Report Type: DA Access Report
Reference Number: 18167
Client: Morson Group
Site Address: 36-38 Rodley Avenue, Penrith NSW

ACCESS REPORT

This Access Compliance Report is to accompany a Development Application for the development proposed at 36-38 Rodley Avenue, Penrith NSW

PRE-ADAPTABLE UNIT 03 AND LIVABLE

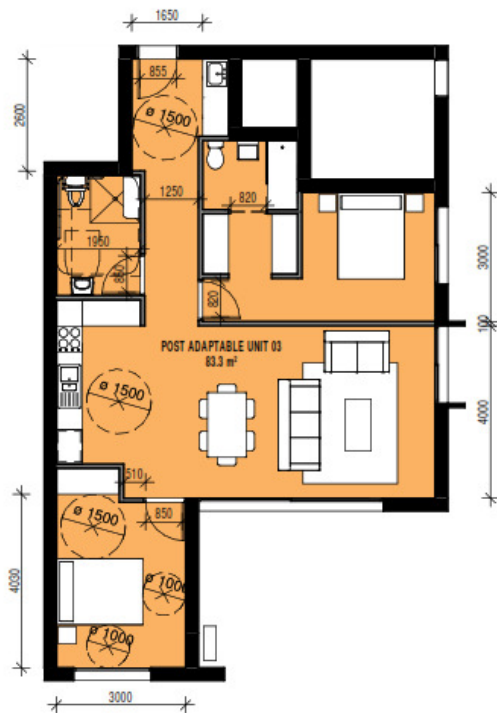
The units designated as adaptable are unit numbers **03, 11 and 12**

At DA stage there is insufficient information to certify compliance with the Standard, however, in accordance with the table below, the nominated units can comply with the spatial requirements of AS4299 for Adaptable Housing.

Main bedroom

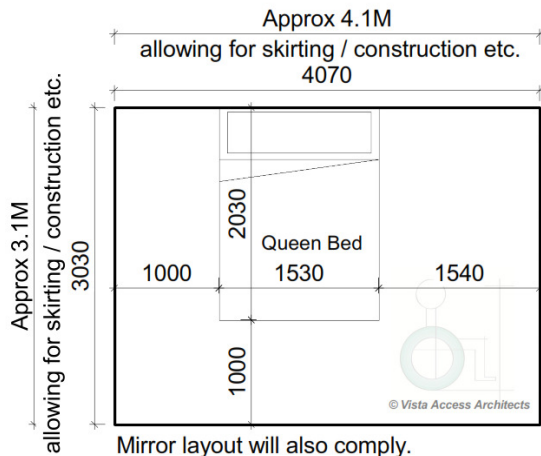
Mirror layout will also comply.

At least one bedroom of area sufficient to accommodate a queen size bed and wardrobe and circulation space requirements of AS1428.2	<input checked="" type="checkbox"/>	<input checked="" type="checkbox"/>	Complies Details to be verified at the CC stage
---	-------------------------------------	-------------------------------------	--

Main Adaptable bathroom

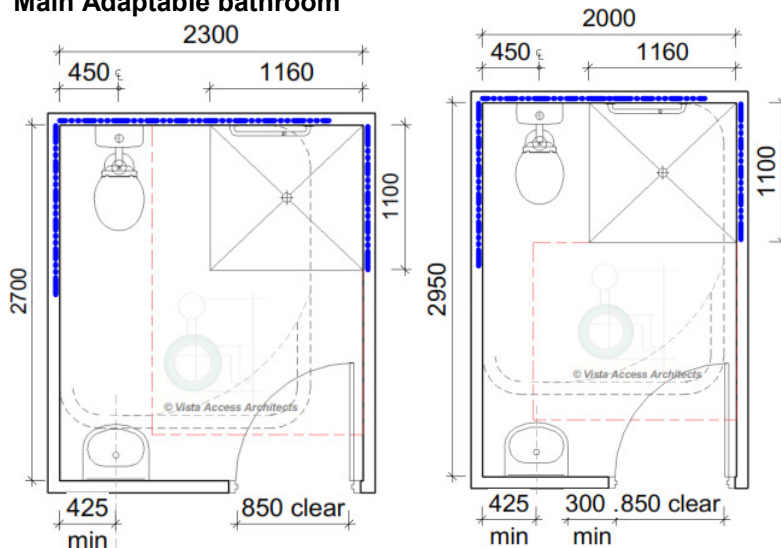
Post Adaptation bathroom layout shown
 Noted dimensions in these diagrams are approximate and depend on selected features such as size of the basin. These dimensions include allowances for reinforcements and normal construction tolerances.
 Thick blue line indicates the location of wall reinforcements which are to be provided at pre-adaptation itself. Red dotted line indicates the shower circulation space. Black dotted line indicates the WC pan circulation space.

<ul style="list-style-type: none"> - Provision for bathroom area with Circulation spaces of Shower and WC (including fixtures) to comply with AS1428.1. - Note that wall reinforcements and waterproofing details to comply with AS4299 	<input checked="" type="checkbox"/>	<input checked="" type="checkbox"/>	Complies A bathroom with minimum space of 2Mx 2.95M or 2.3Mx2.7M or 2.4Mx2.45M is achievable. Wall reinforcement details to be verified at the CC stage.
---	-------------------------------------	-------------------------------------	--
